**PROPOSED GULL SERVICE STATION 1 DP 341981, MOLESWORTH DRIVE, MANGAWHAI
RESOURCE CONSENT APPLICATION NUMBER: RM 220251
ADDITIONAL TRAFFIC INFORMATION**

As requested, we have considered the request for additional information received from Kaipara District Council (KDC) and the Northern Transport Alliance (NTA) in relation to the proposed Gull Service Station at Lot 1 DP 341981 Molesworth Drive in Mangawhai. For ease of reference in our response we have numbered and repeated the respective query (in *italics*).

Figure 1 – Approved Molesworth Drive Vehicle Access

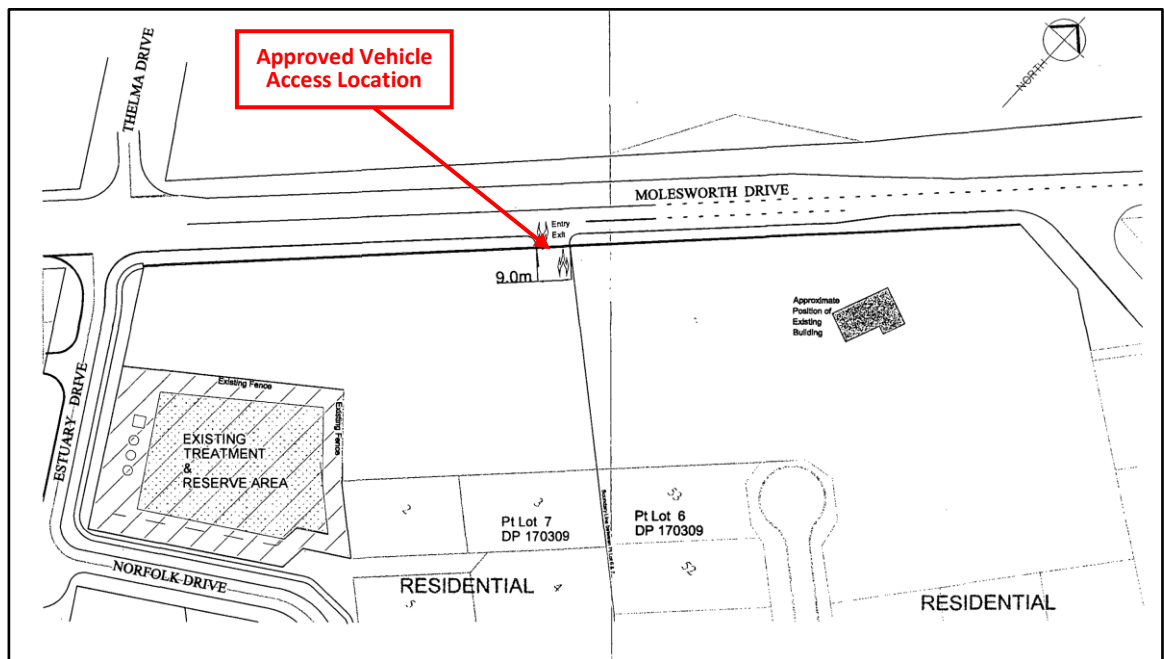
2. *The proposed 2-way vehicle crossing.*
– *We do not approve the western VC over the segregation strip. Has the applicant considered alternative location for the VC? Applicant is to address the possibility of not having the 2-way VC as part of their modelling. In AEE it has been specified that the proposed western access will be utilized as an exit-only.*

The segregation strip on Molesworth Drive was established in 2005 as a way to safely manage vehicle access to Molesworth Drive when it had a posted speed limit of 100km/hr. The approved access is shown in Figure 1 and is essentially in the same location as the existing eastern vehicle crossing that will be used to access the proposed Gull Service Station and the adjacent development.

Given that the speed limit on Molesworth Drive has been reduced to 50km/hr compared to the 100km/hr speed limit that was in place when the segregation strip was installed, it is difficult to understand the continuing need for the segregation strip as the reasons for its implementation are no longer present.

Figure 3 – Weekday PM Peak Hour Vehicle Crossing Turning Movements

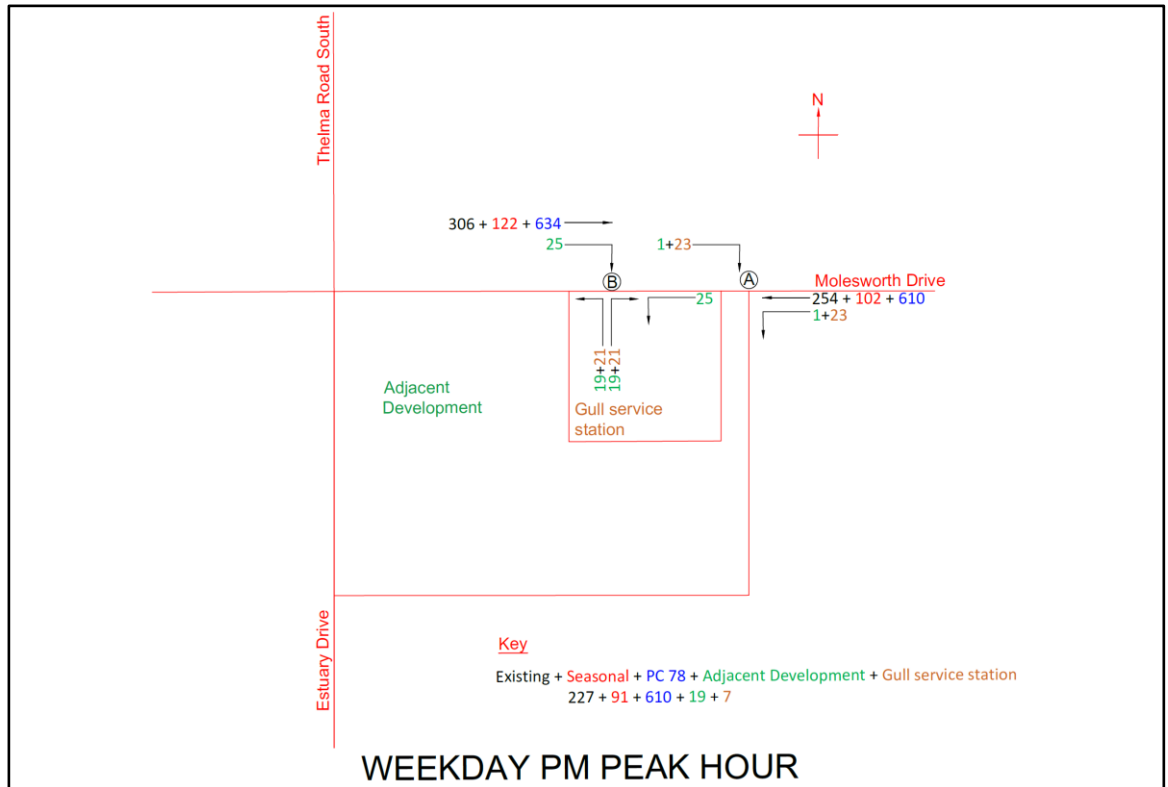
3. *The typical traffic generation for service station is 2.5% – 3% of passing traffic.*
– *Request the applicant to provide further information on how 2.5%-3% traffic generation was determined, and adequate reasoning is to be provided. In research report 453 the trip generation rates (peak hour) for NZ 2010 has been specified as 20.4/bay and the trip generation utilised to carry out the modelling, appears to be low. Request the applicant to carry out the modelling again.*

Nevertheless, for further assessment purposes we have adopted a traffic generation of 90 traffic movements per hour.

The resulting turning movements from this are shown in Figure 3 for the Weekday PM Peak Hour and in Figure 4 for the Saturday Midday Peak Hour.

The SIDRA modelling results confirms that the vehicle access will operate well within its capacity for the traffic generated by the Gull Service Station and the adjacent proposed development.

Figure 1 – Proposed Vehicle Crossing

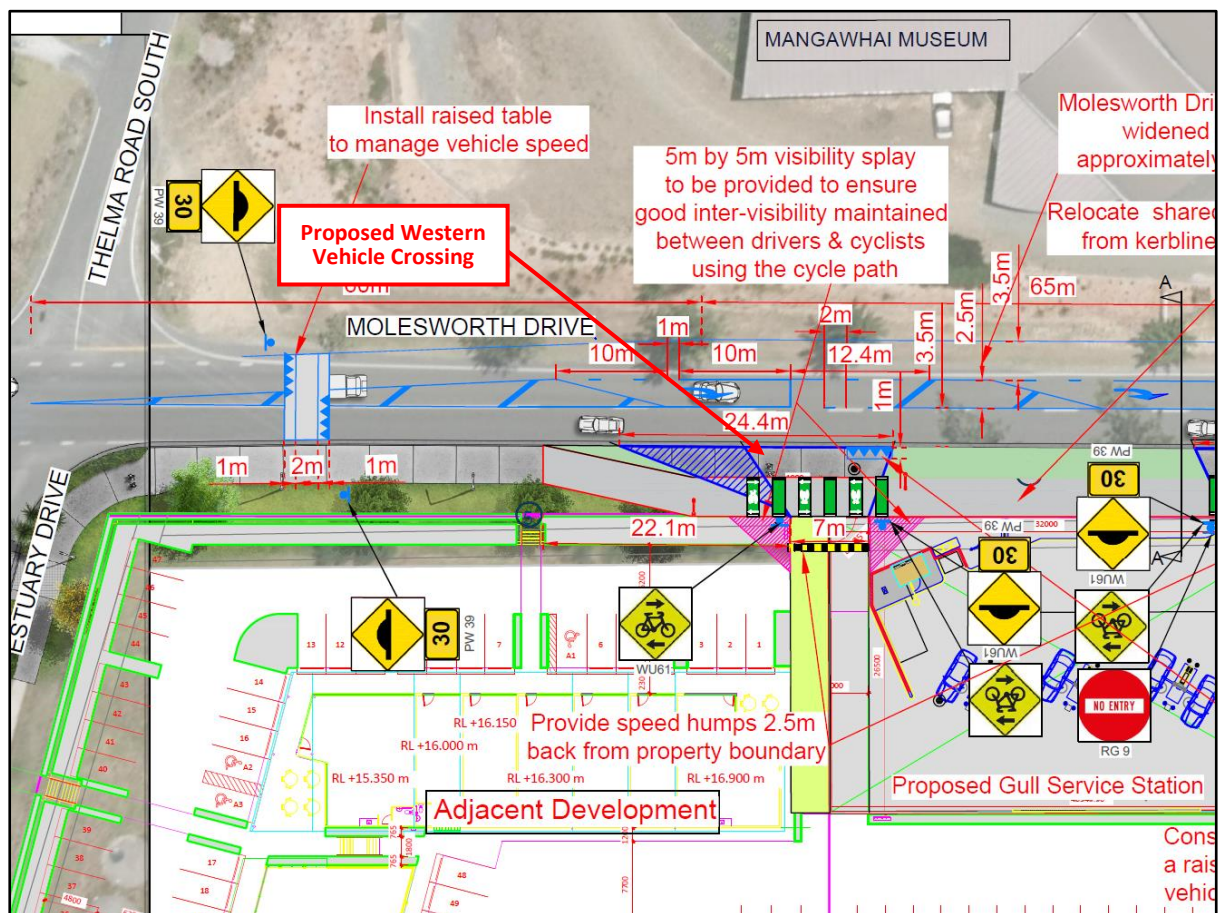
4. *Applicant is to carry out Safe system assessment for the vehicle crossings and the report is to identify if the proposed treatment is primary/ secondary/ non-safe system compliant. Primary treatment is to be proposed to mitigate the effects on shared path*

A 3.5 metre wide shared pedestrian / cycle path is provided on the southern side of Molesworth Drive and runs along the kerbline in this location. As part of the proposal the shared pedestrian / cycle path would be relocated against the property boundary to provide separation from the through traffic lane and to minimise the effective width of the vehicle crossing and potential conflict area.
